# Service Bulletin

Bulletin No.: P11294

**Subject:** Intermittent Service Power Steering Message Displayed on DIC, DTC C056D, C0475 or U0131 May Be Set

**Models:** 2012-2014 Buick LaCrosse  
2014 Buick Regal  
2014 Cadillac XTS  
2014 Chevrolet Impala  
Equipped with Belt Drive Electronic Power Steering (RPO NJ2)

3775857

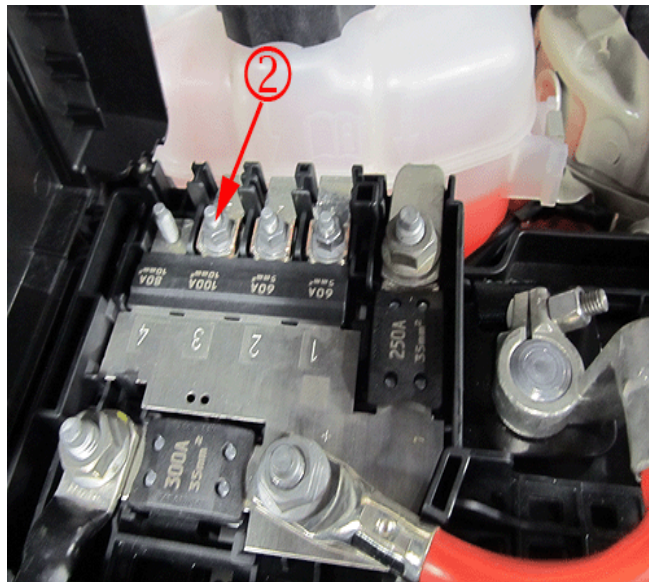
1. Inspect the G111 ground (1) and the 100A F3UB fuse (2) for proper connection. Ensure the ground is free of paint and both connections are tight.

- Tighten the G111 ground to 9 N•m (80 lb in).
  - Tighten the F3UB fuse to 4.7 N•m (42 lb in).
2. Fully charge the battery using the GR-8 Tool (EL-50313).
  3. Reprogram the power steering control module using the Service Programming System (SPS) with the latest calibrations available on TIS2WEB. Refer to the Power Steering Control Module Programming and Setup (NJ2) procedure in SI.
